**CERTIFICATE OF APPROPRIATENESS**

**Property:** 1123 Oxford Street, Lot 7, Block 196, Houston Heights Subdivision. The property includes a historic 2,146 square foot, one-story wood frame single-family residence and detached garage situated on a 6,600 square foot (50' x 132') interior lot.

**Proposal:** Alteration – The applicant was denied a COA at the June and July HAHC meetings to construct a rear 1-story side addition and a rear 2-story addition to a 1-story residence. The applicant has resubmitted the application with one change from the July submission:

**NORTH SIDE ELEVATION**

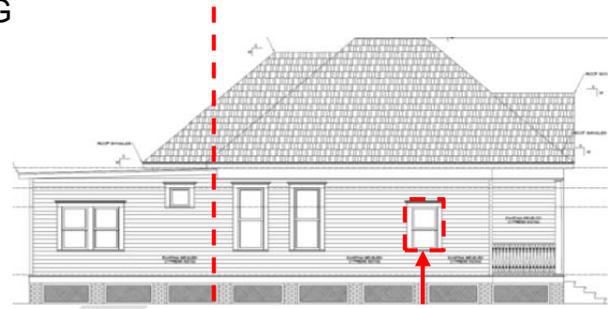
- The one-story side addition on the north elevation will be inset 3'-8" from the existing north wall and the proposed gable roof and set of shutters have been removed. The one-story addition will measure 8'-3" wide and 12'-4" deep.
- The rear addition will be inset 6" on the south elevation at the original rear corner.

PROPOSED – addition is 4' shorter in total length

**SITE PLAN  
EXISTING**

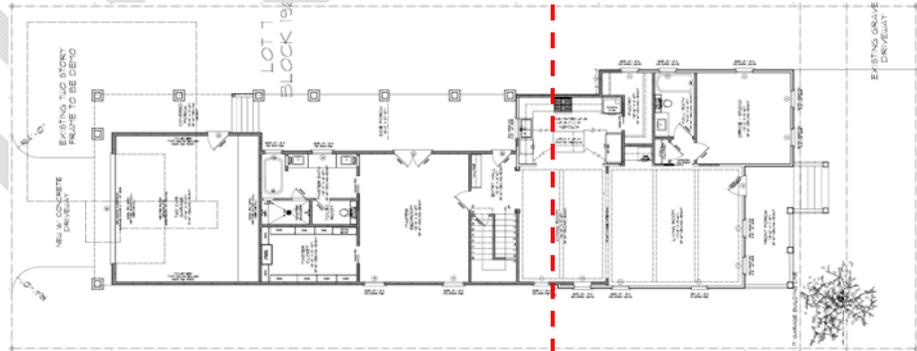
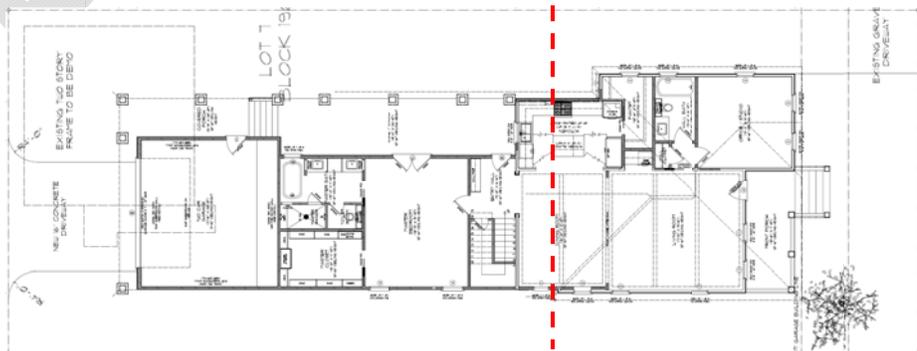
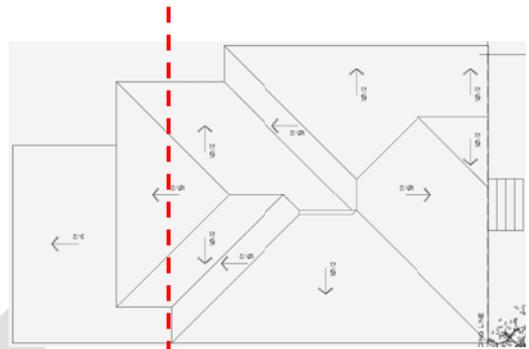
**PROPOSED - addition is 4' shorter in total length**

**ROOF PLAN  
EXISTING**

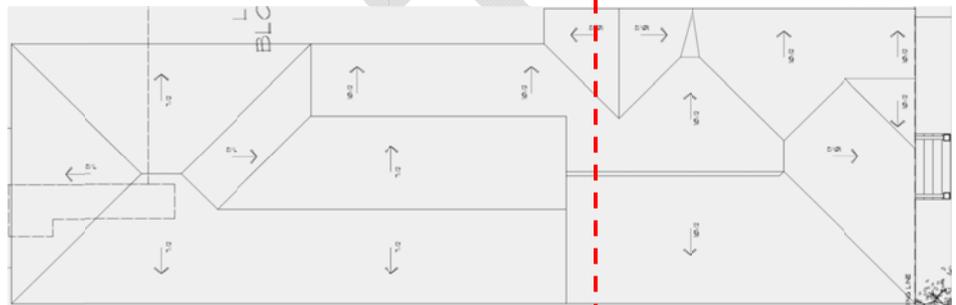
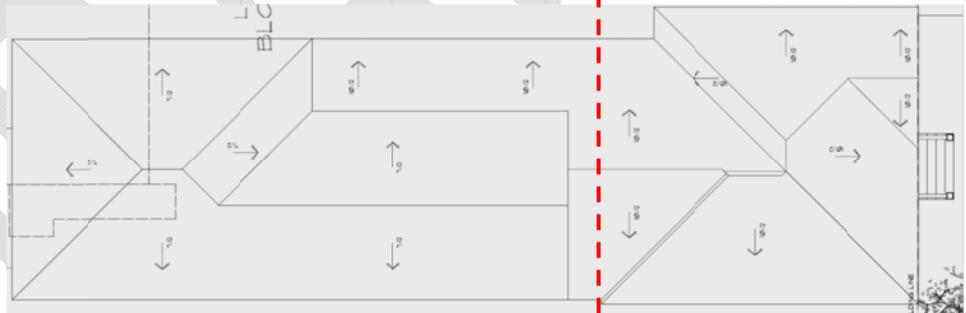
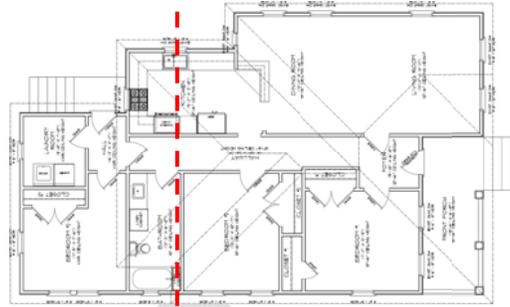
**PROPOSED - addition is 4' shorter in total length**

**FIRST FLOOR PLAN**

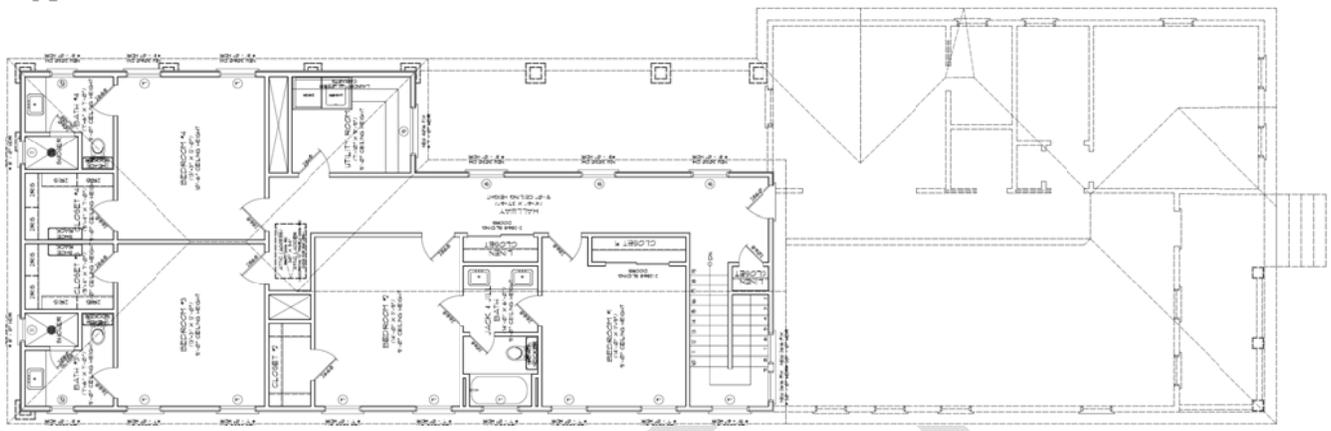
PROPOSED - addition is 4' shorter in length

**SECOND FLOOR PLAN**

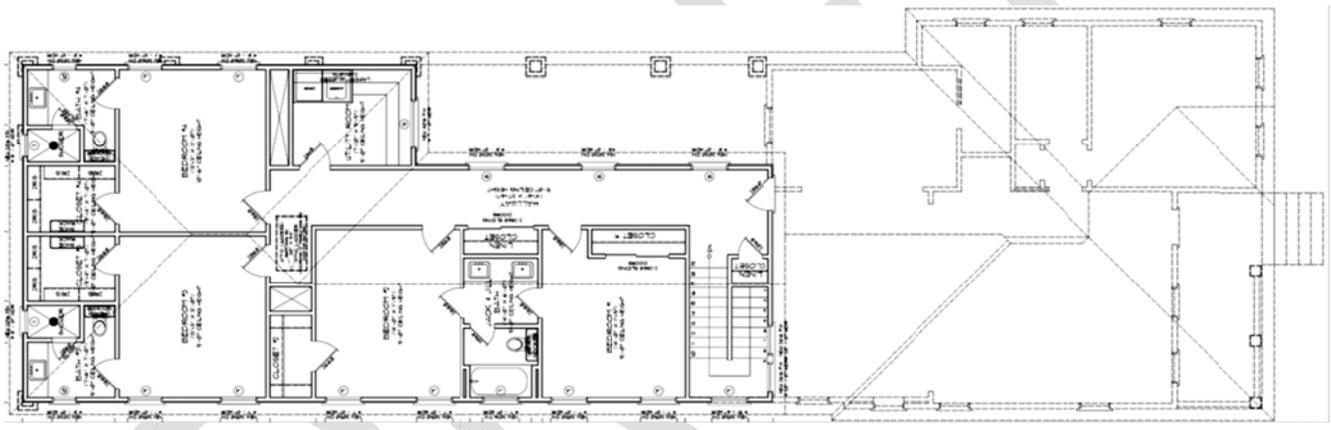
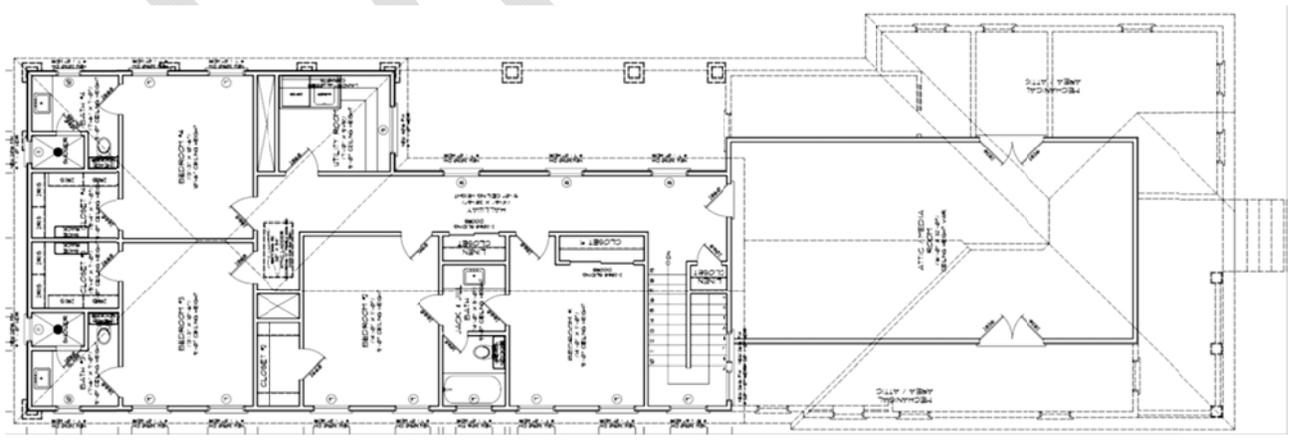
PROPOSED - addition is 4' shorter in total length
